THE WINSTON

Lot 199 - Oakmont Valley View

The Winston

CLIENT:	MCKEE HOMES, INC.
SCOPE:	STRUCTURAL ADDENDUM
LOT #:	
ENG. KWT/DTN	
REV:	
DATE:	11-16-2017

1st Floor Plan 'Coastal'
 SCALE: 1/4"=1'-0" AT 22"x34" LAYOUT 1/8"=1'-0" AT 11"x17" LAYOUT

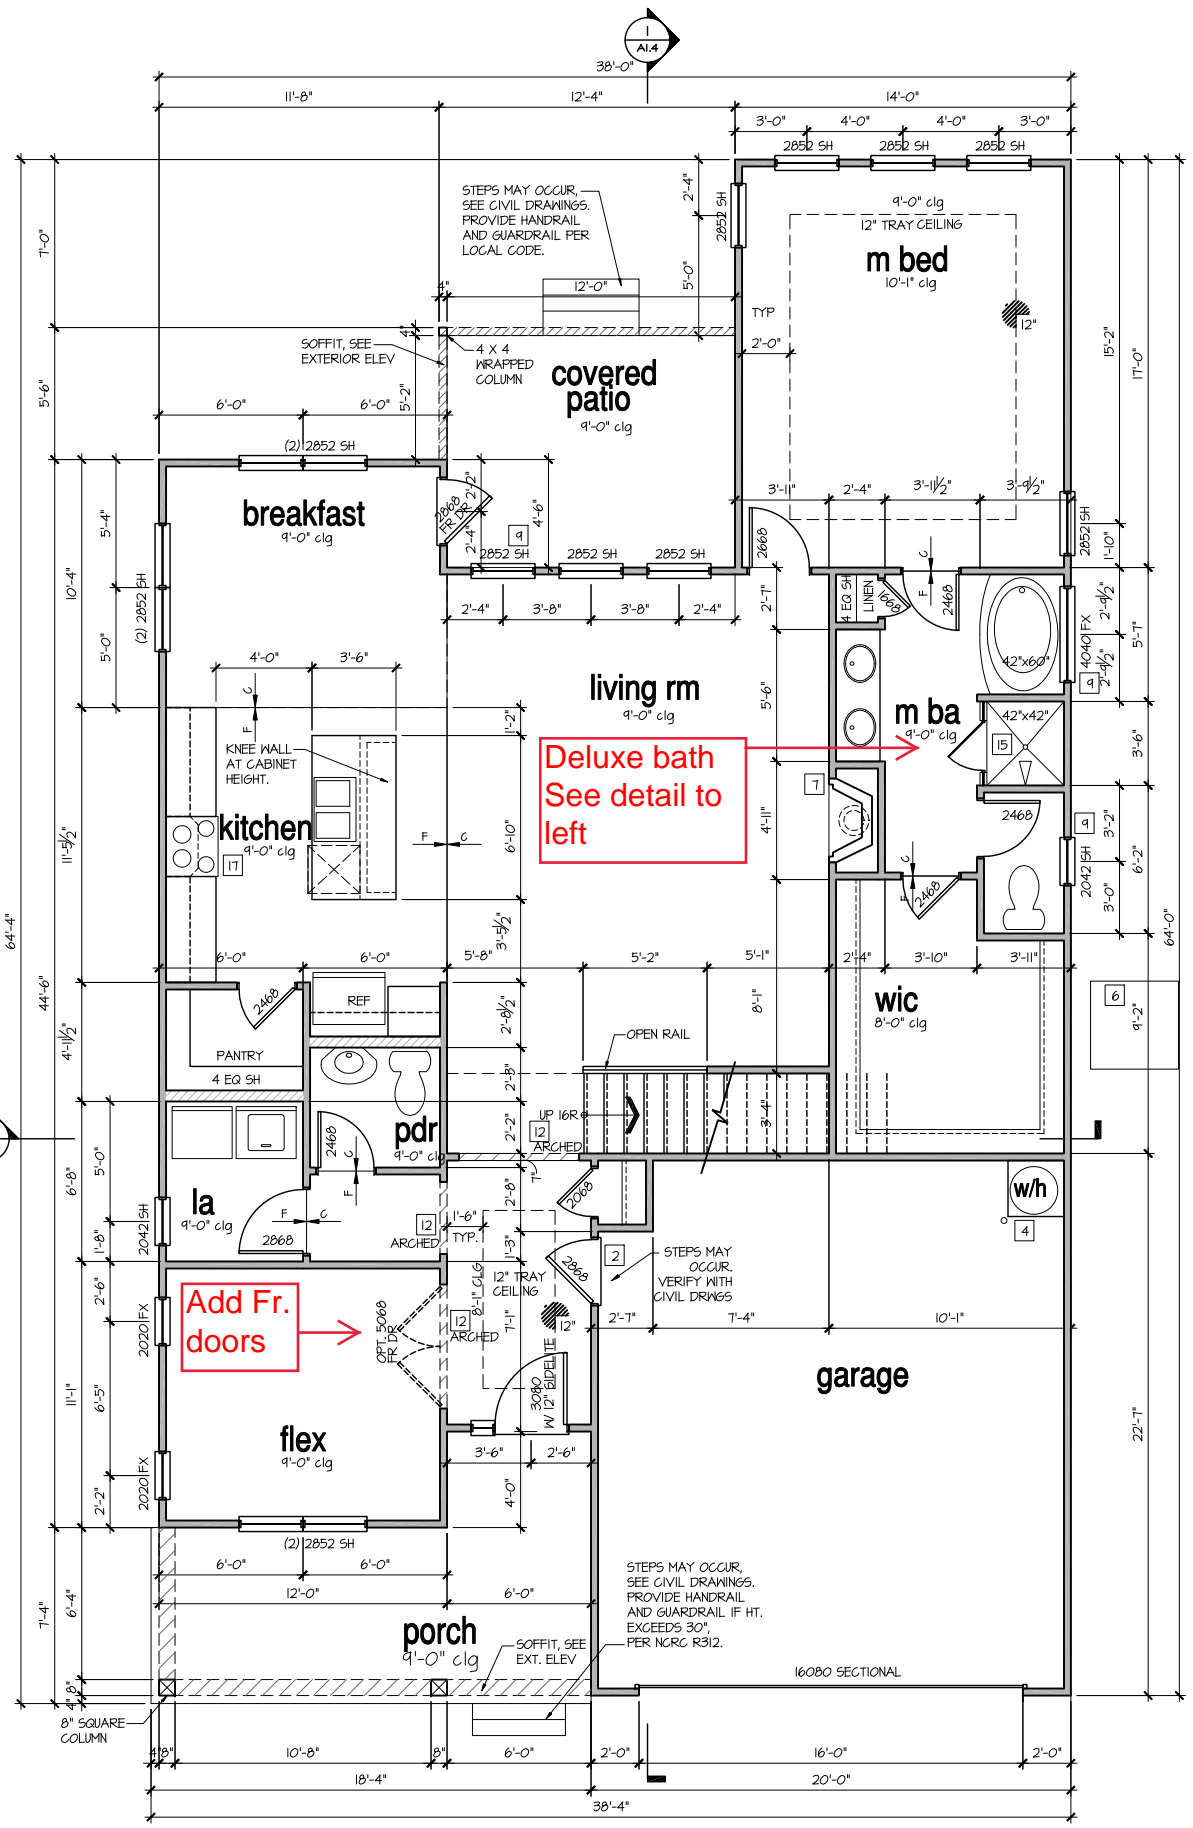
Accessible 36" doors on all main doorways. Do not include secondary doorways/ linen closets

Craftsman
 See next pg

FOUNDATION PLAN
CRAWLSPACE OPTION
COASTAL ELEVATION

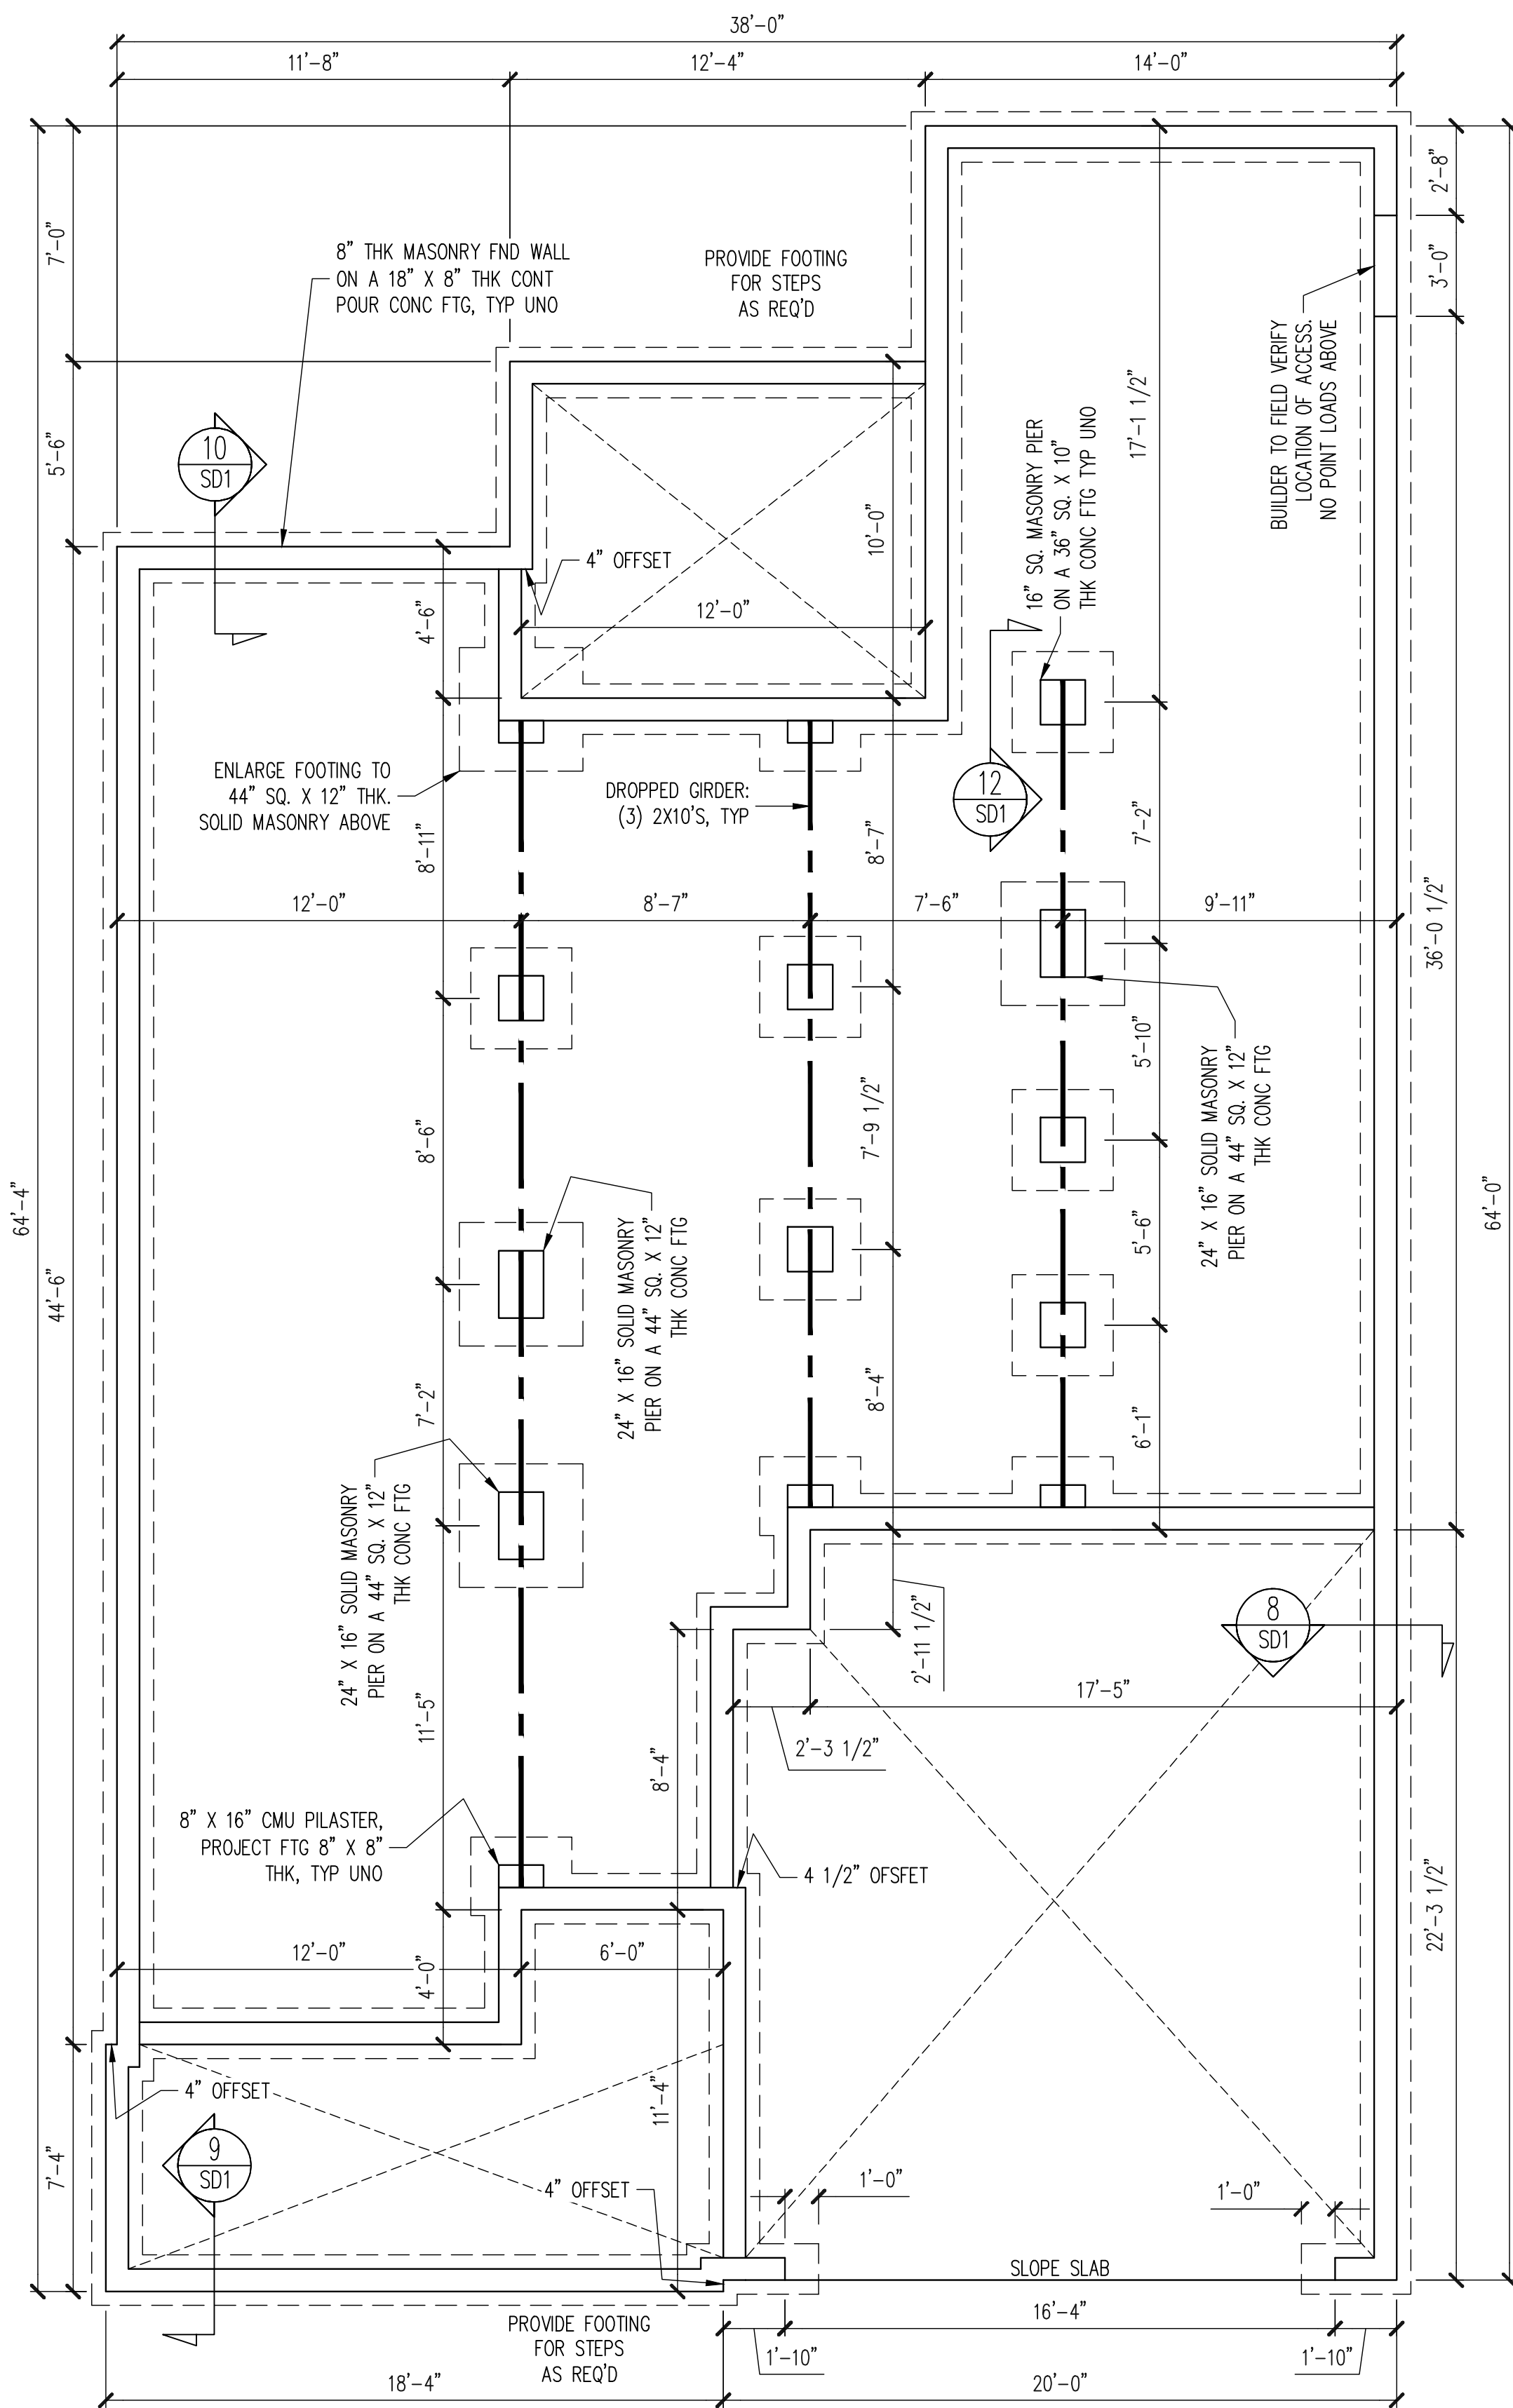
Craftsman
See pg S7

CRAWL SPACE FRAMING PLAN
COASTAL ELEVATION

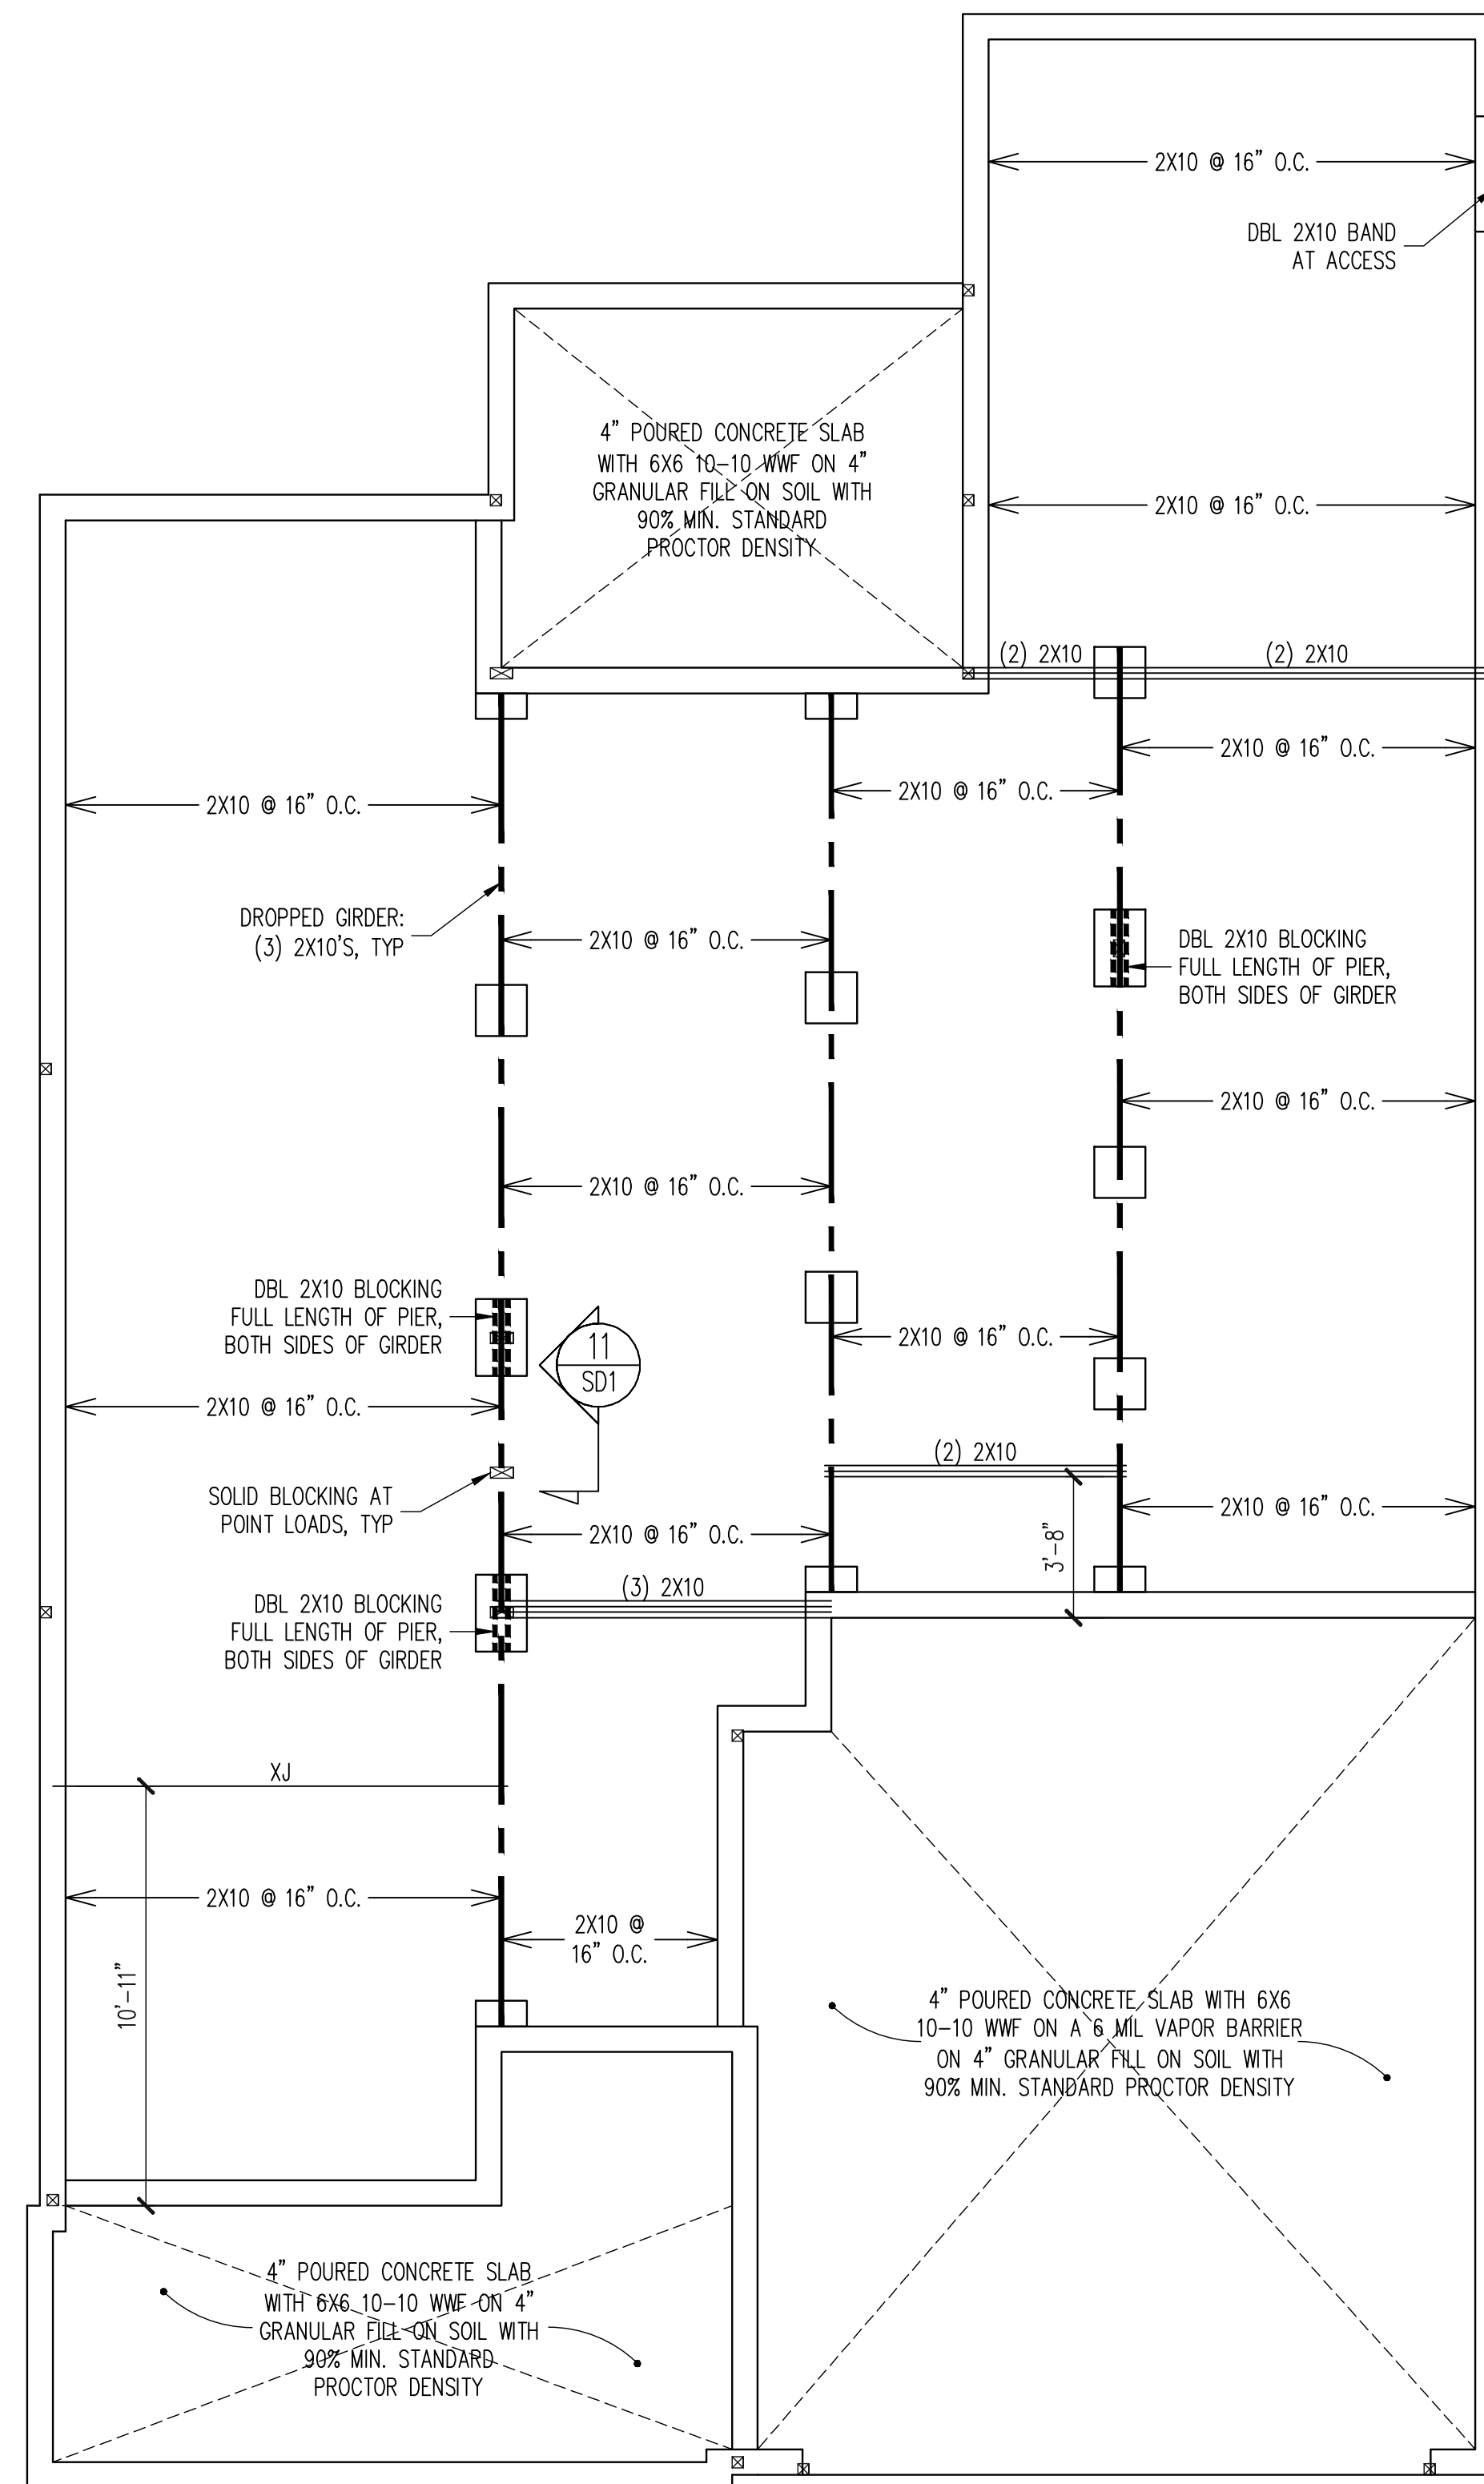
Craftsman
See pg S8
